REMARKS

Application Serial No. 10/699,275
REPLACEMENT SHEET

FIG. 1

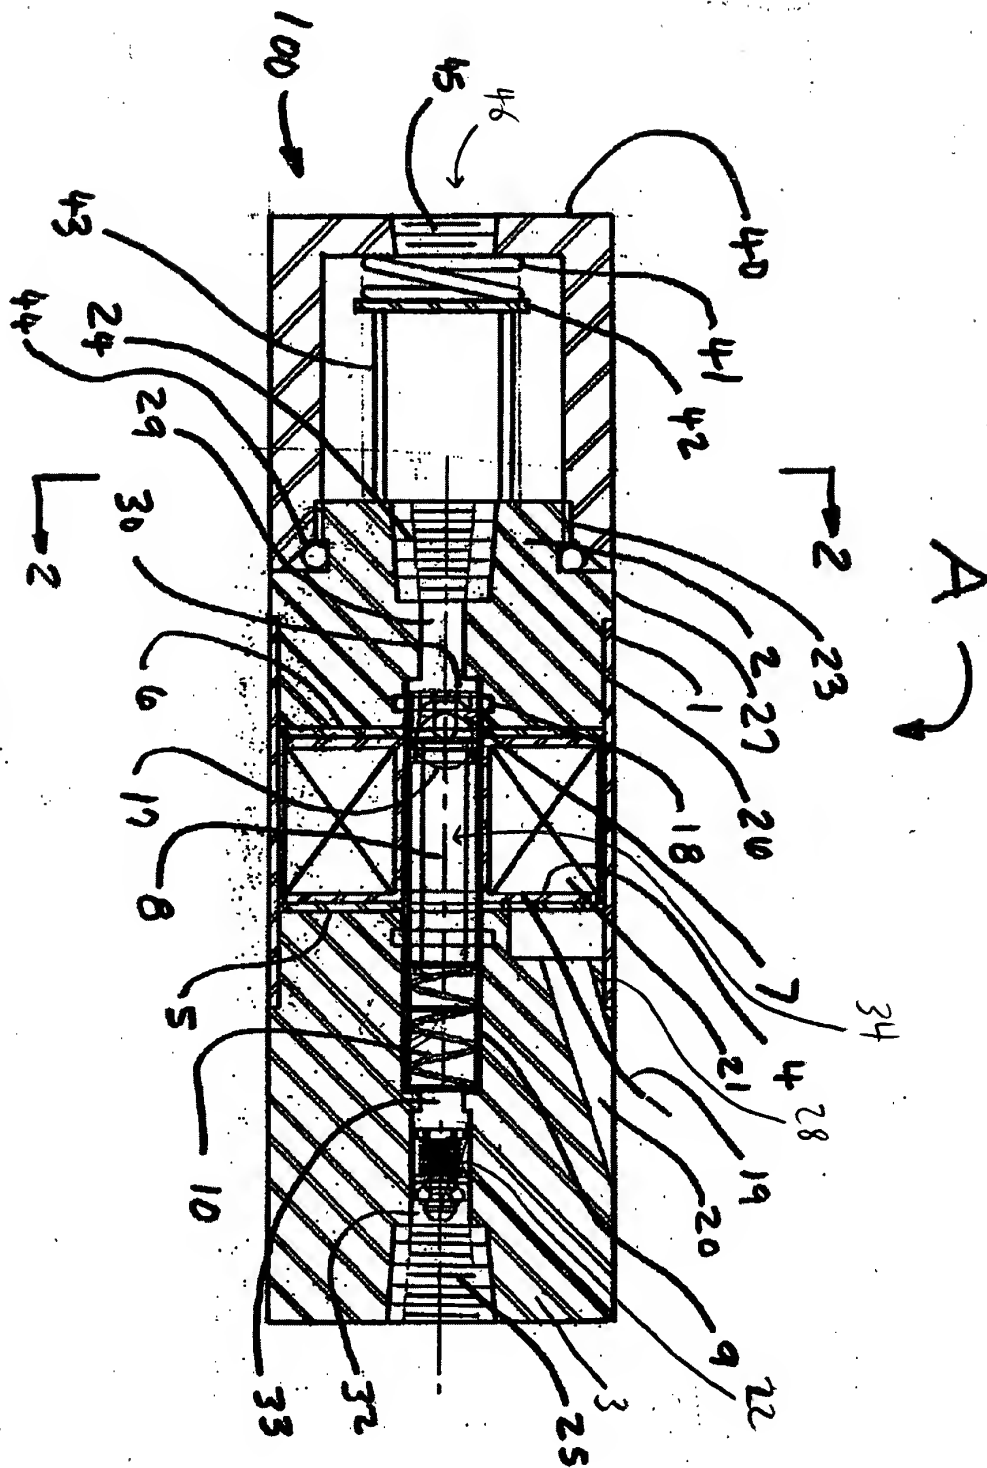
The Examiner has further objected to the drawings, specification and claim 29 based upon form, and Applicant has amended the drawing and specification to comply with the Examiner's requirements.

Numerals 3, 28 and 34 have been added to Fig. 1, and Figs. 1 and 2 have been enlarged for clarity. No modifications have been made to Figs. 1 and 2 except the addition of numerals. The lead line for numeral 22 in Fig. 1 has been moved. The internal structure of check valve 22 is not shown because check valves are known in the art. The structural relationship of piston 8, piston end cap 7 and machine ball 17 should be clearer now that Figure 1 has been enlarged. Formal drawings will be supplied to Examiner shortly.

been labeled numeral 46 in the figure for the Examiner's understanding. On page 6, "axially" has been amended to "axial."
